Groundwater Review Summary Form

Application # G- 18381

PUBLIC INTEREST REVIEW FOR GROUNDWATER APPLICATIONS

TO: Water Rights Section Date January 19, 2017
 FROM: Groundwater Section Michael J Thoma
Reviewer's Name
 SUBJECT: Application G- 18381 Supersedes review of _____
Date of Review(s)

Stream-depletion Model Output

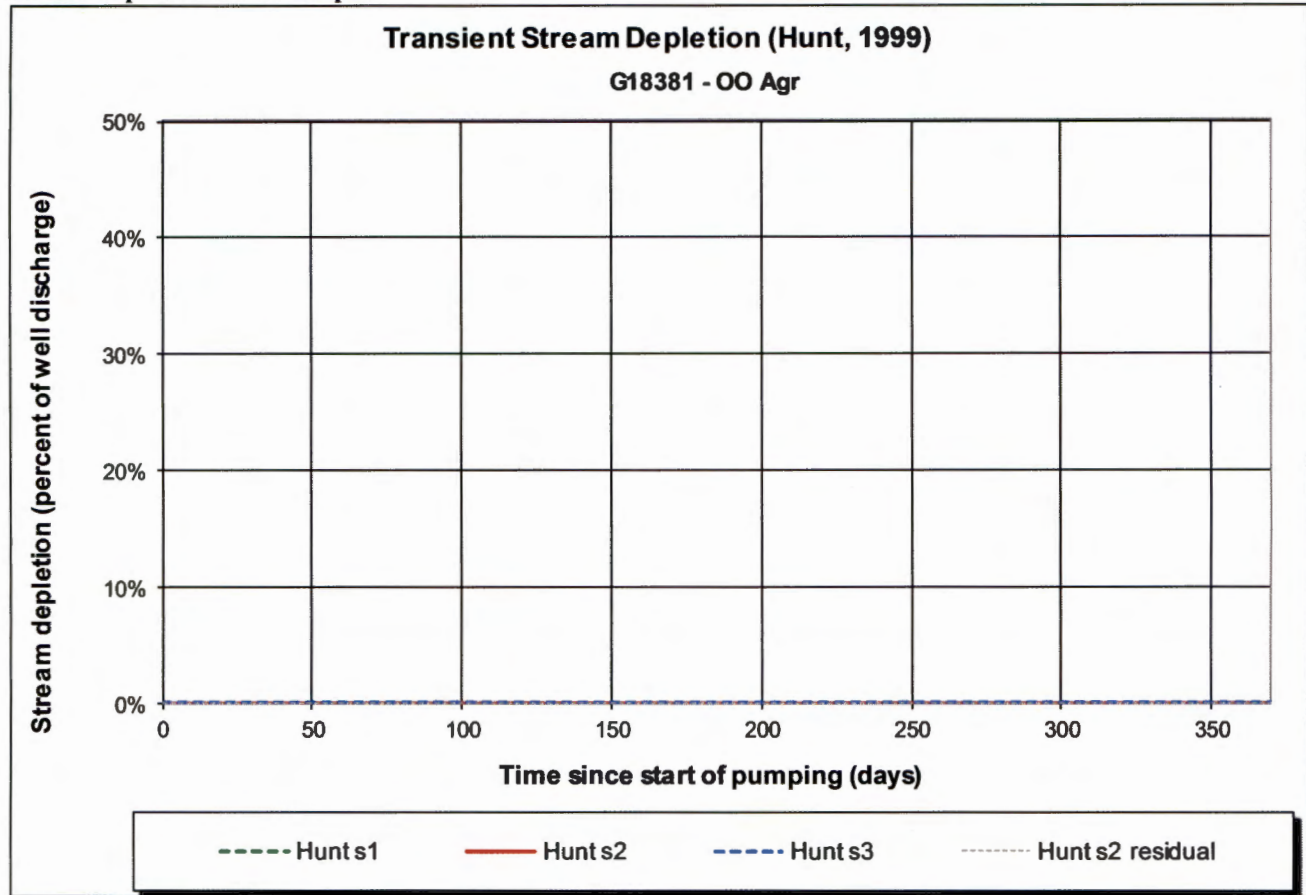
Basis for impact evaluation: The Hunt (1999) analytical stream-depletion model was used to estimate impacts to surface water. Parameters used were considered in the range of weathered alluvial sediments.

C6. **SW / GW Remarks and Conditions:** The applicant's proposed well would be producing from an aquifer that has been found to be hydraulically connected to surface water at a distance of > 1 mile. However, the reviewer is unable to find a preponderance of evidence that the proposed use will have the Potential for Substantial Interference (PSI) with surface water.
